Re: *Addendum No. 1*
Roosevelt Park – Bocce Court
City of Campbell

Date: April 8, 2020

CITY OF CAMPBELL
BOCCE COURTS AND PAVILION
CAMPBELL, OHIO
MAHONING COUNTY
PLANS AND DETAILS

PROJECT NO.	190901
DISCIPLINE	ARCHITECTURAL
SHEET NAME	A-01
SHEET	OF
5	9

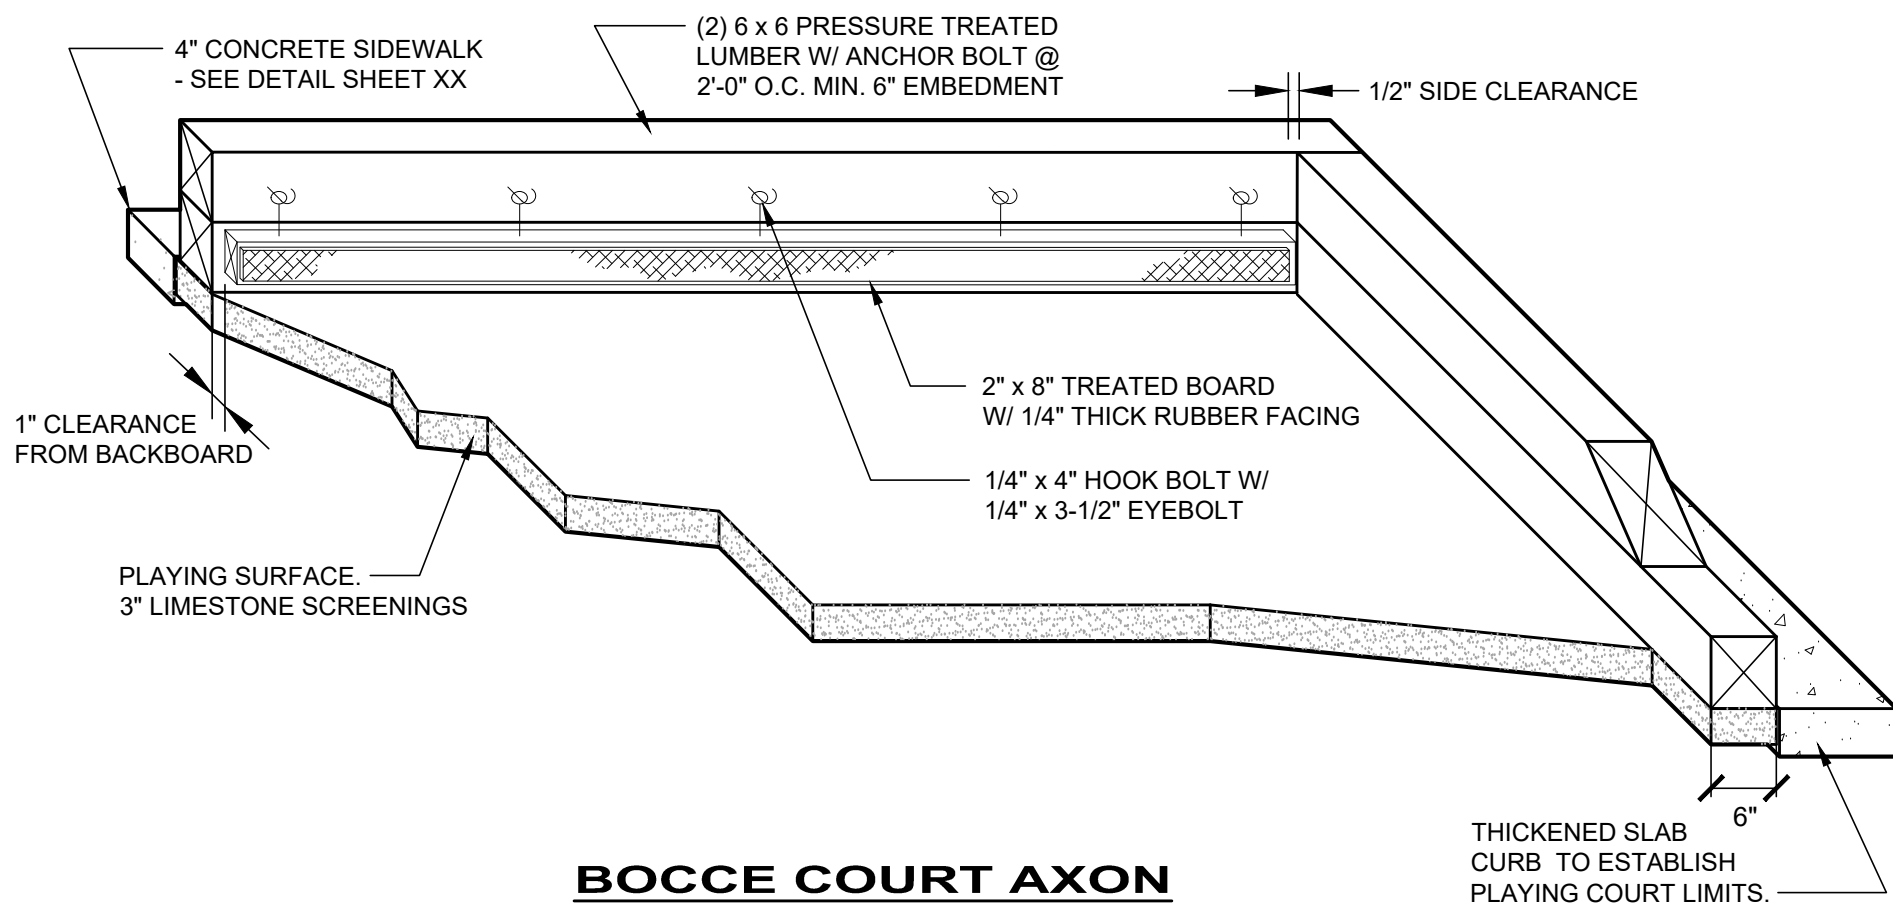
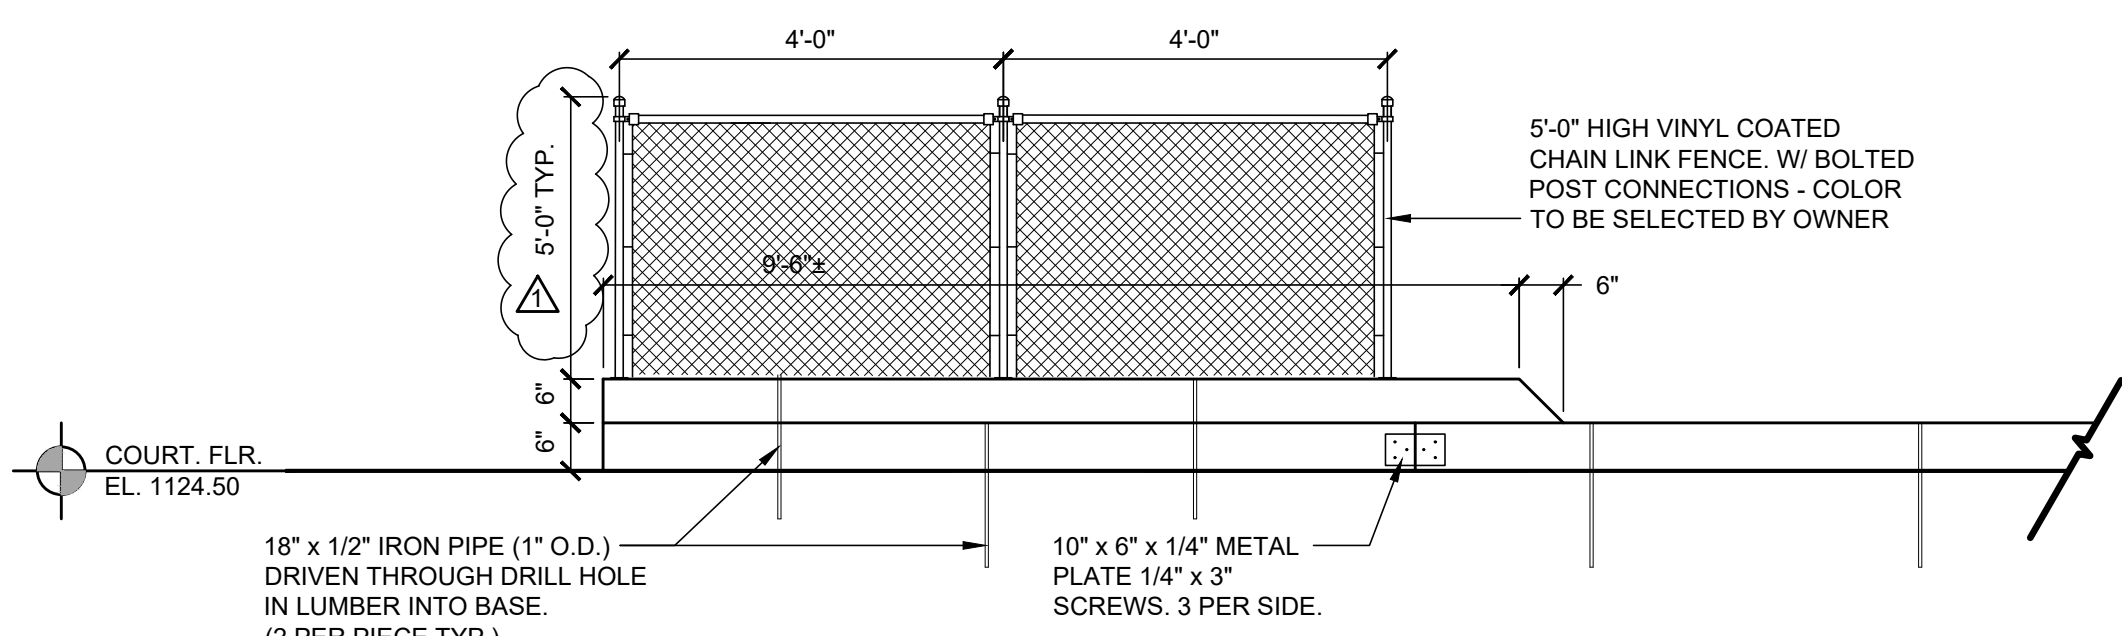
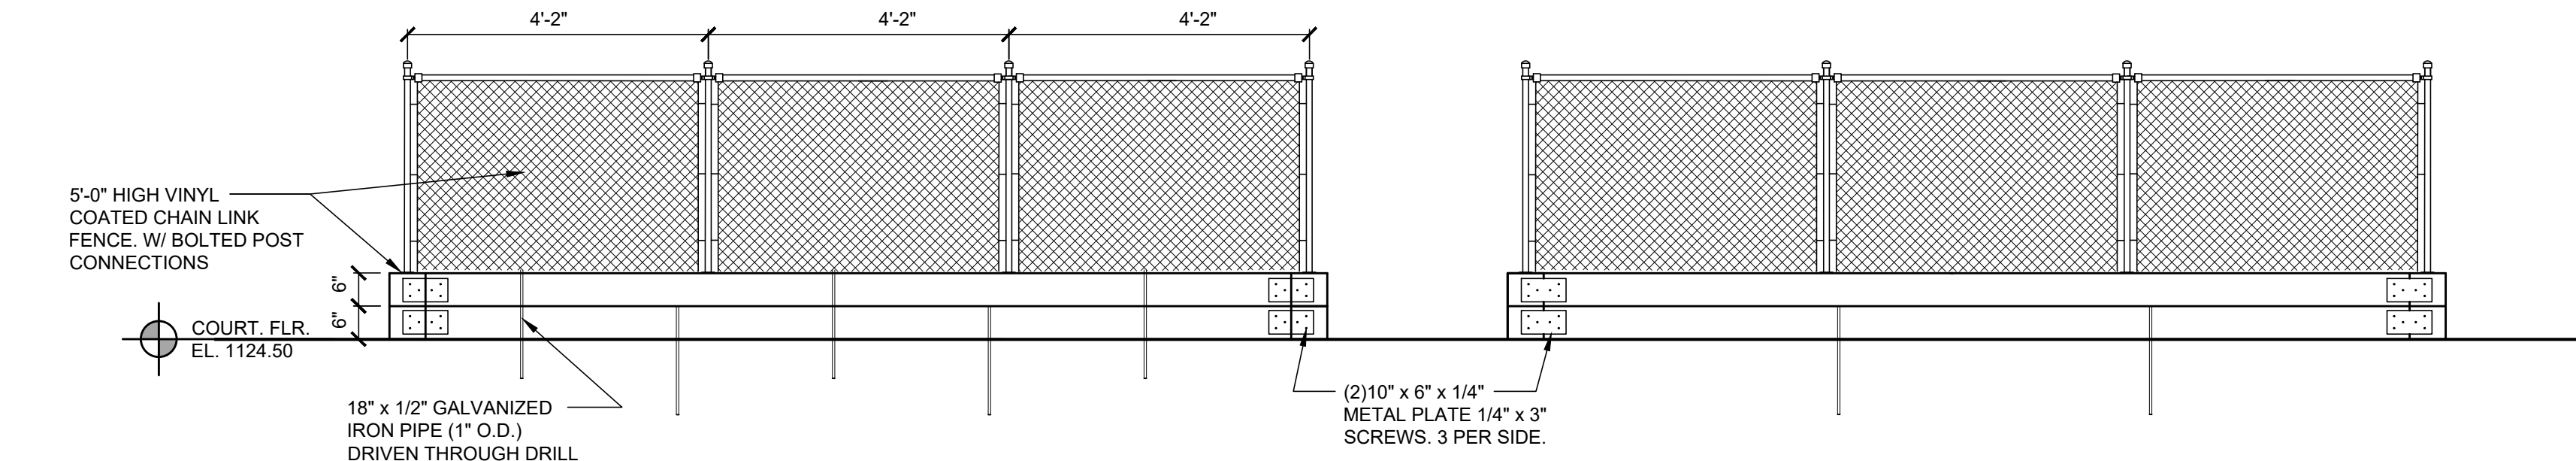
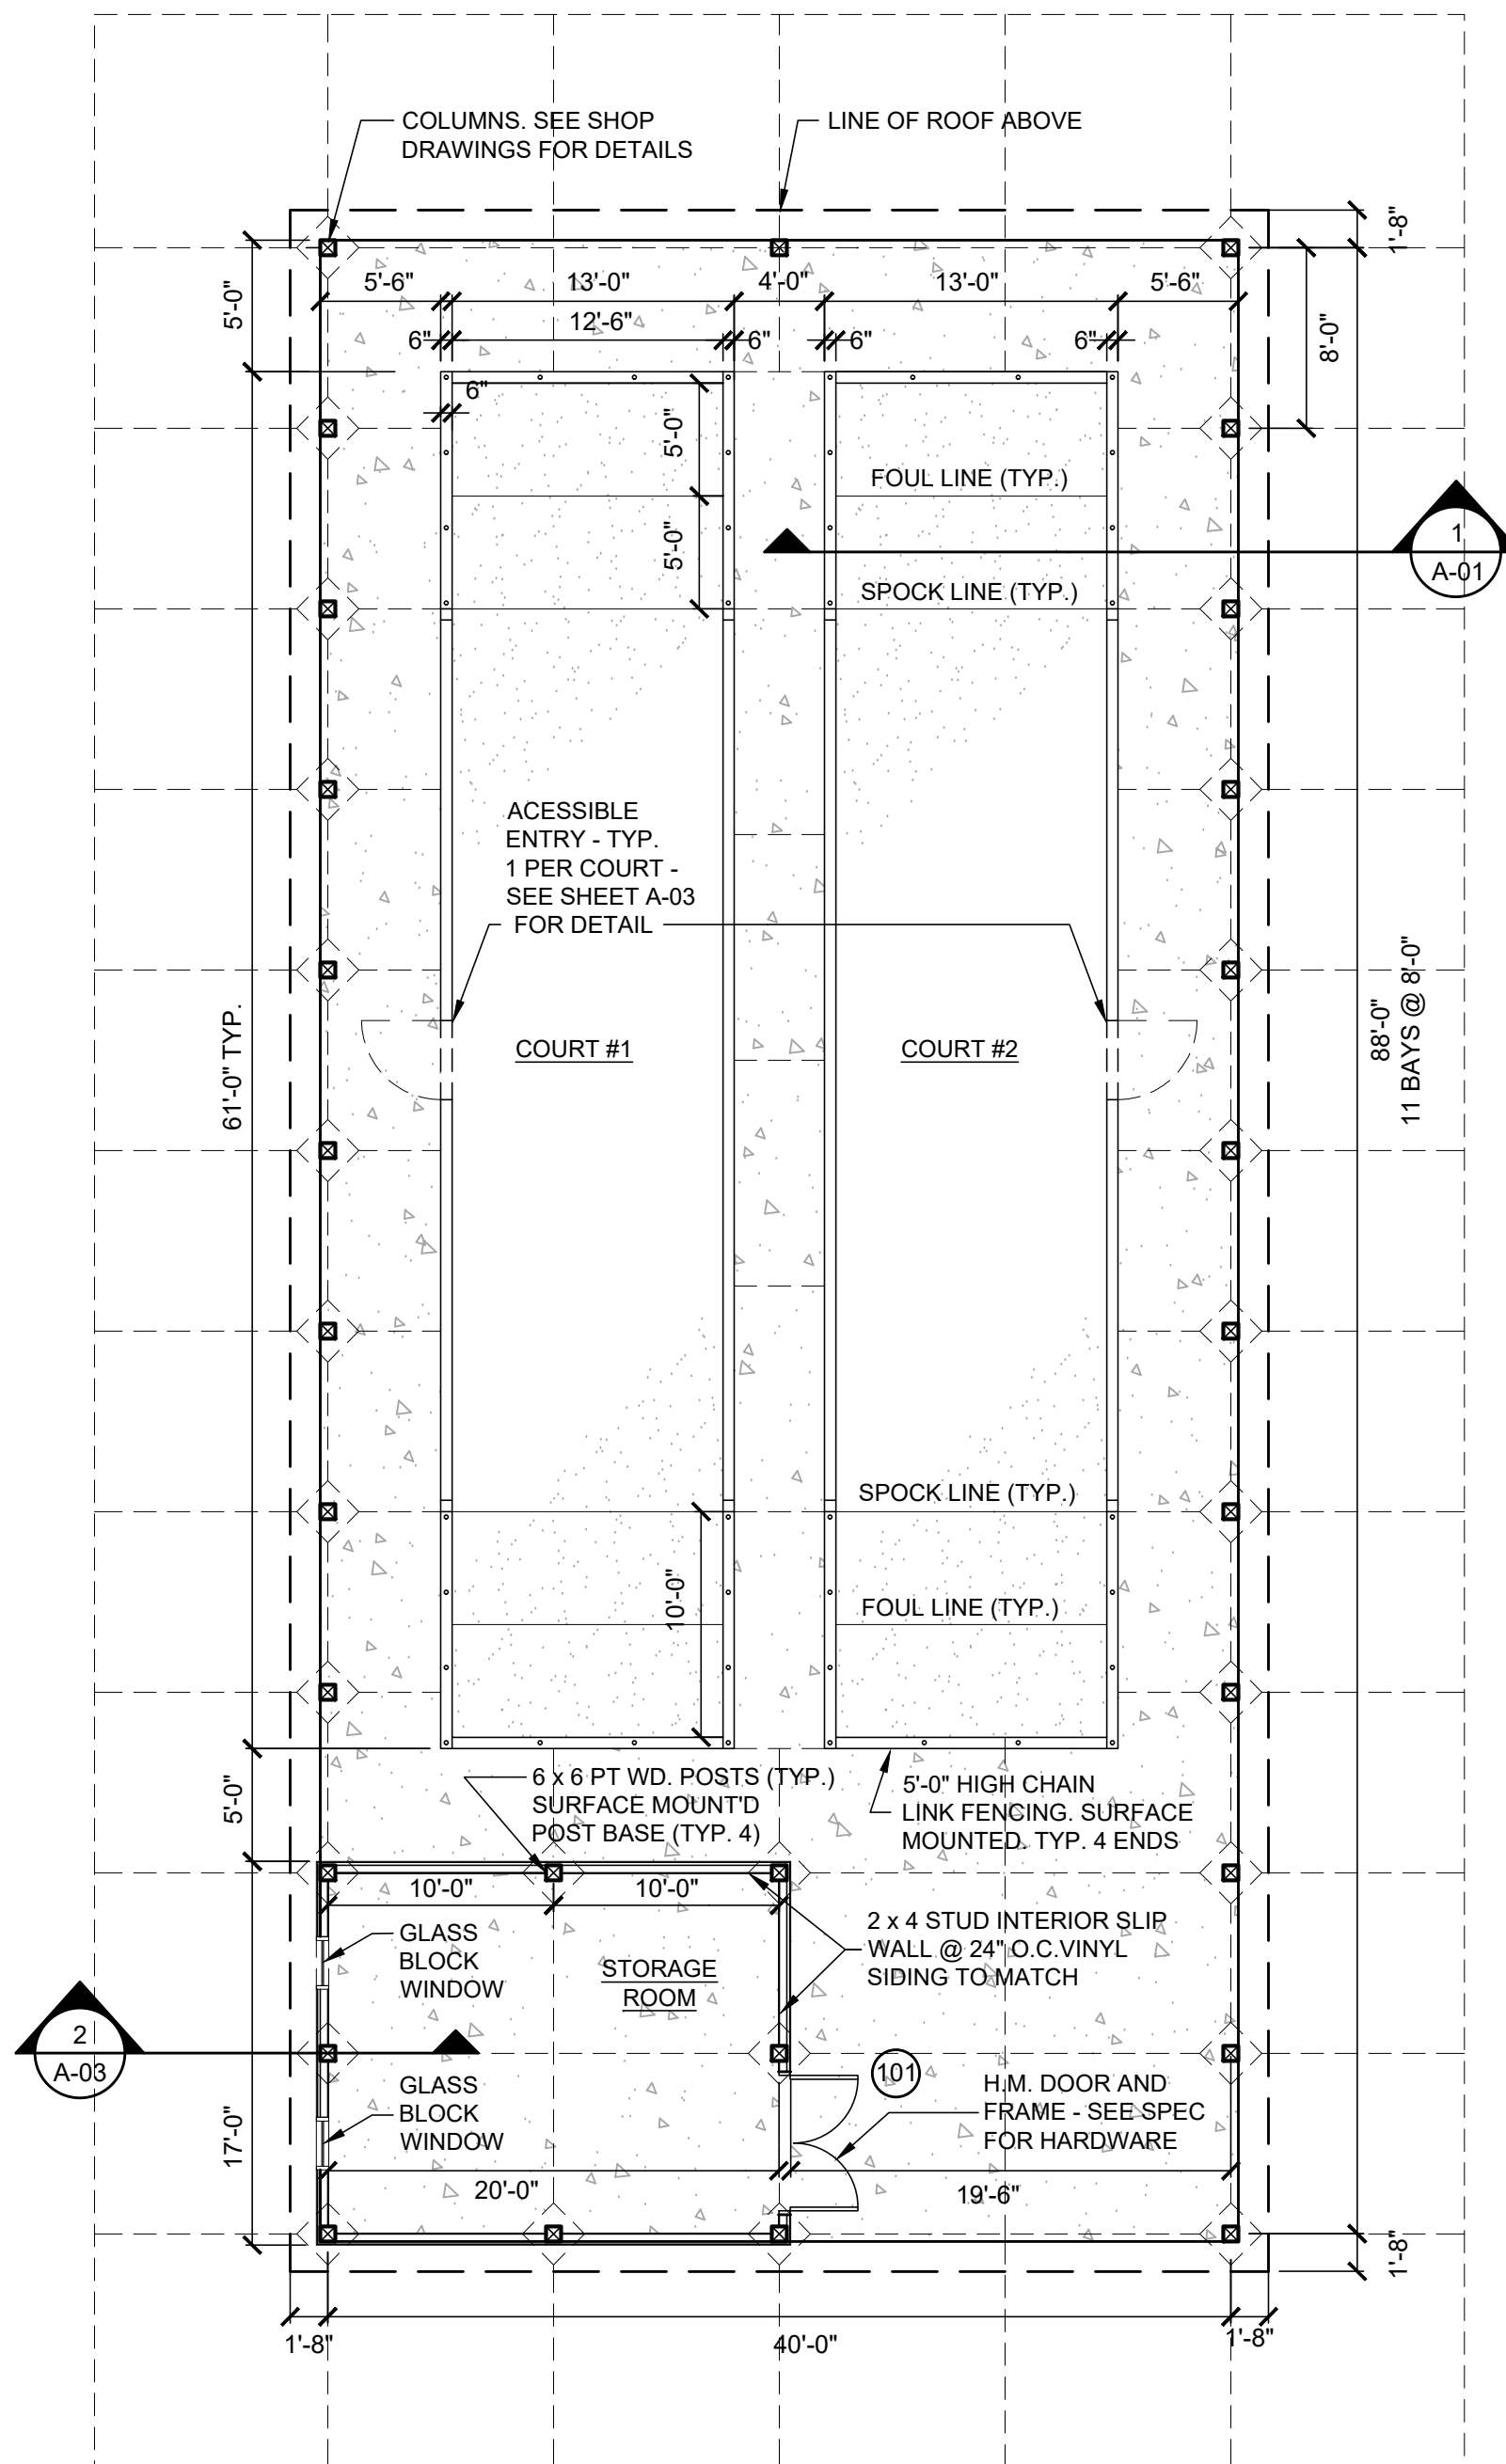
Delete and Replace: Drawing A-01, Plans and Details with revised sheet dated 4/2/2020.

ISSUED FOR:	BID	ISSUE DATE:	SCALE:	DESIGNED BY:	PAW	DRAWN BY:	PAW	CHECKED BY:	ADT
REVISIONS	DESCRIPTION	DATE	REVISIONS	DESCRIPTION	DATE	REVISIONS	DESCRIPTION	DATE	REVISIONS
1	ADDITIONAL 1 - COURT DETAIL CLARIFICATION	4/22/2020
